ORIGINATION FORM

Proposed Revisions to a Standard Plans Index
(Please provide all information — Incomplete forms will be returned)

Index Number: 455-001

Index Title: Square Prestressed Concrete Piles - Typical
Details & Notes

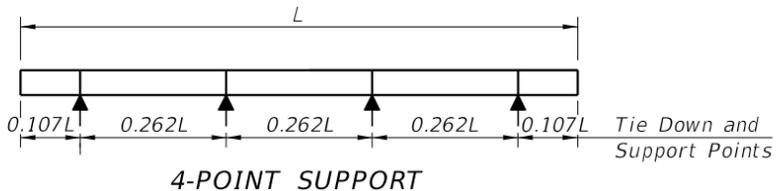
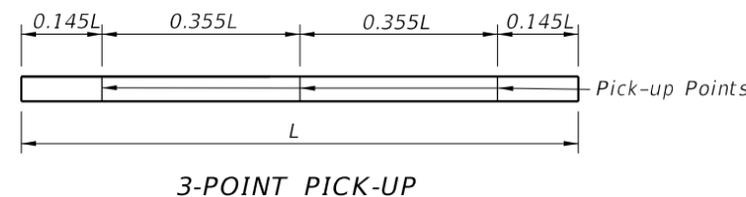
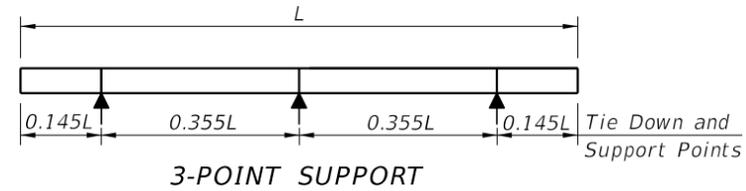
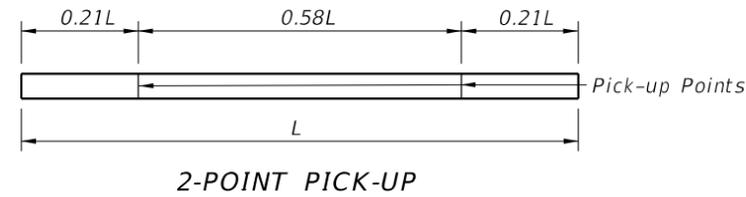
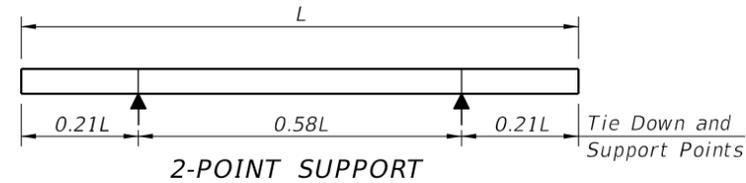
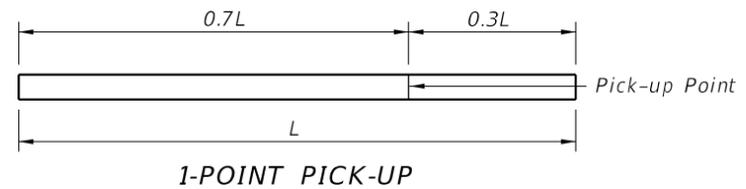
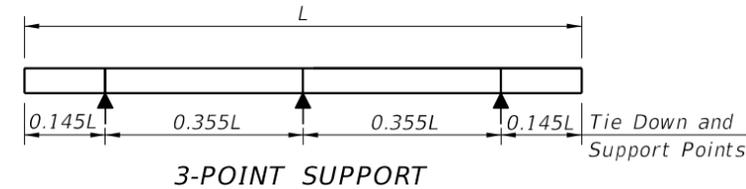
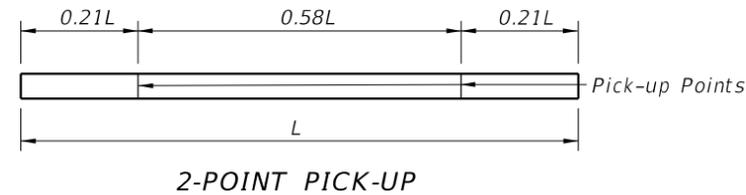
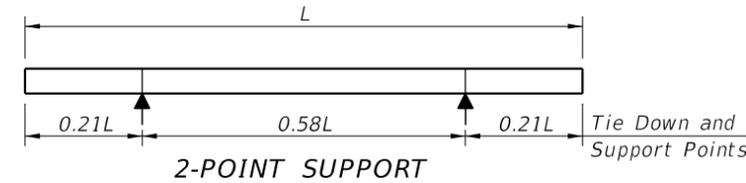
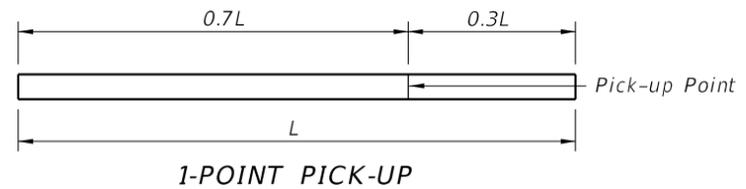
Change Silica Fume, metakaolin or ultra-fine flyash to Highly Reactive Pozzolans

Specification changed to fit silica fume, metakaolin and ultra-fine flyash under Highly Reactive Pozzolans

- C. Silica Fume: See "GENERAL NOTES" in the Structures Plans for locations where the use of silica fume, metakaolin or ultra fine flyash is required.

Highly Reactive Pozzolans

- C. See "GENERAL NOTES" in the Structures Plans for locations where the use of Highly Reactive Pozzolans is required.
3. Concrete strength at time of prestress transfer:
